SECTION

3/4.2 POWER DISTRIBUTION LIMITS

3/4.2.1 AVERAGE PLANAR LINEAR HEAT GENERATION RATE

Reduced Flow MCPR Operating Limit
This Curve is Applicable to ANF Reload Fuel, GE Initial Core Fuel,
ANF D X D LFA Fuel, GE 11 LFA Fuel, and SVEA-96 LFA Fuel
This curve is also applicable to FFTR operation
Figure 3.2.3-1

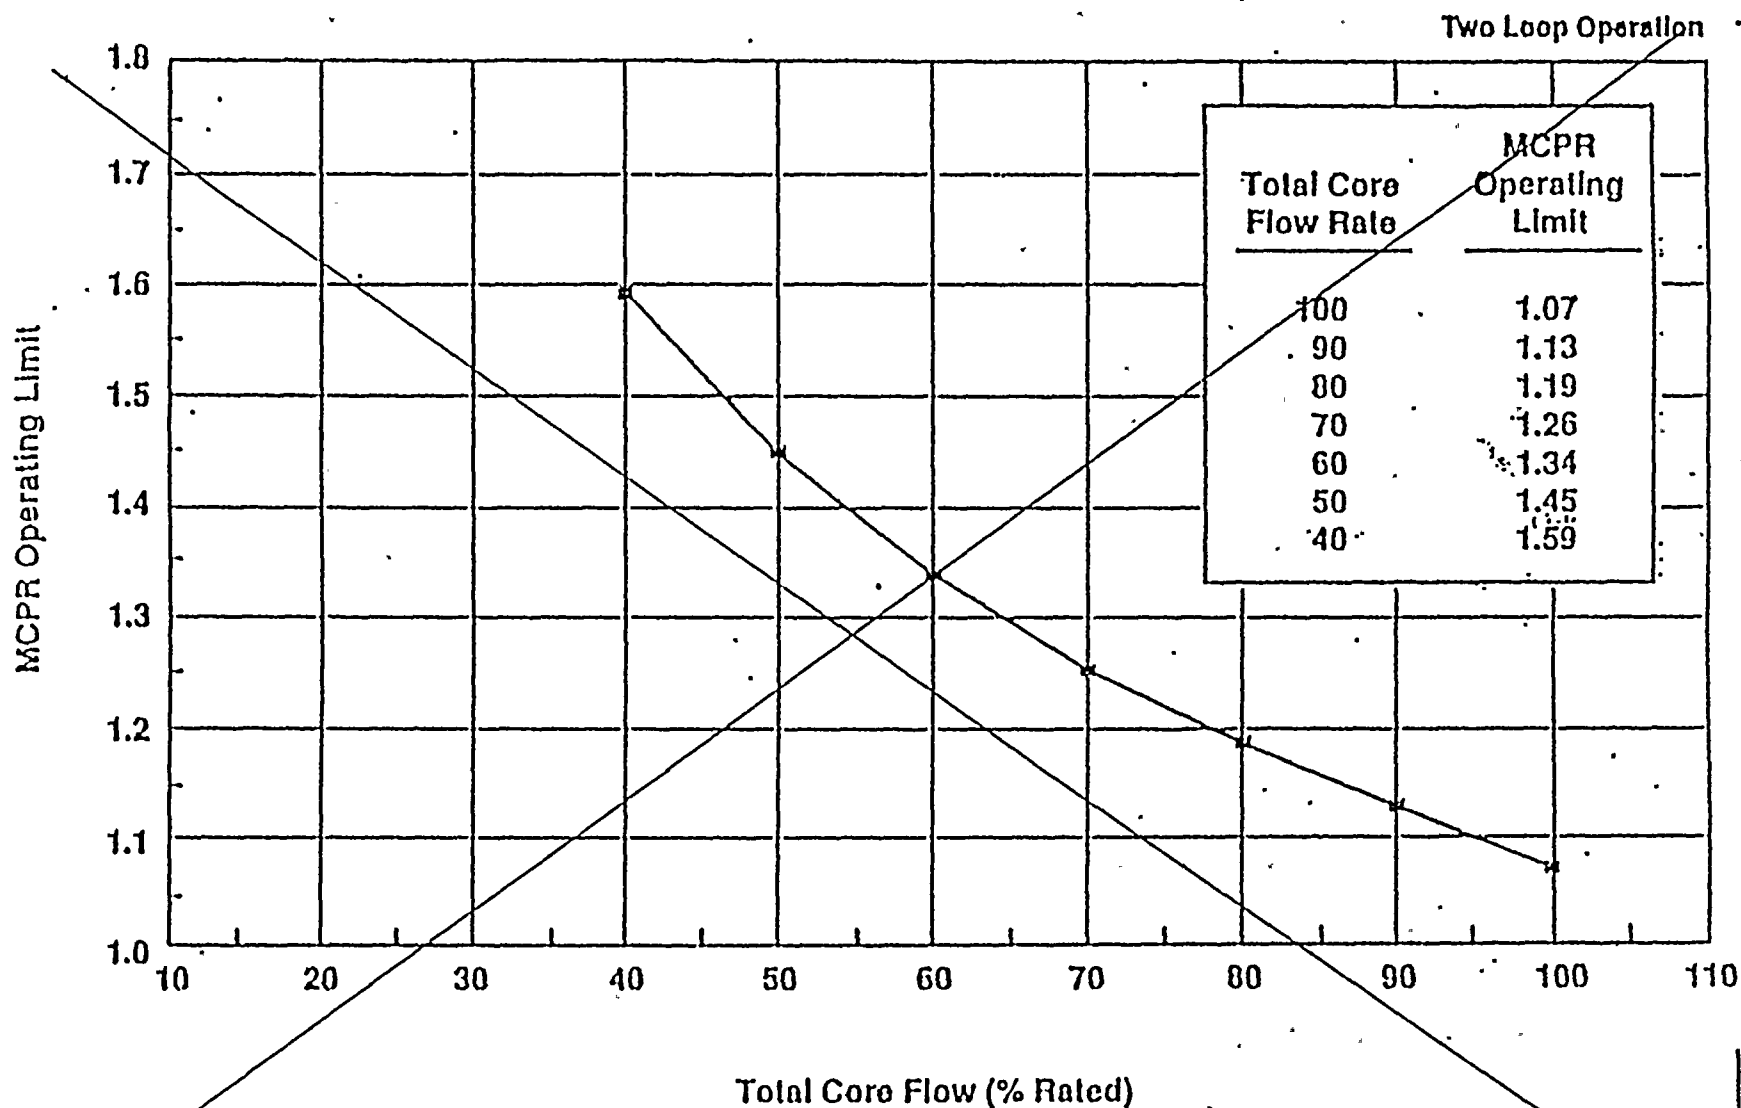
ACTION: With MCPR less than the applicable MCPR limit ~~determined from Table 3.2.3-1 and Figure 3.2.3-1~~ *specified in the Core Operating Limits Report*, initiate corrective action within 15 minutes and restore MCPR to within the required limit within 2 hours or reduce THERMAL POWER to less than 25 percent of RATED THERMAL POWER within the next 4 hours.

4.2.3.1 MCPR shall be determined to be greater than or equal to the applicable MCPR limit ~~determined from Table 3.2.3-1 and Figure 3.2.3-1~~ *specified in the Core Operating Limits Report.*

^{FLOW DEPENDENT SPECIFIED IN THE CORE OPERATING LIMITS REPORT}
The purpose of the MCPR_f of ~~Figure 3.2.3-1~~ is to define operating limits at other than rated core flow conditions. At less than 100% of rated flow the required MCPR_f is the maximum of the rated flow MCPR ~~determined from Table 3.2.3-1~~ and the reduced flow MCPR ~~determined from Figure 3.2.3-1~~. MCPR_f assures that the Safety Limit MCPR will not be violated. ^{BOTH SPECIFIED IN THE CORE OPERATING LIMITS REPORT.} MCPR_f is only calculated for the manual flow control mode. Automatic flow control operation is not permitted.
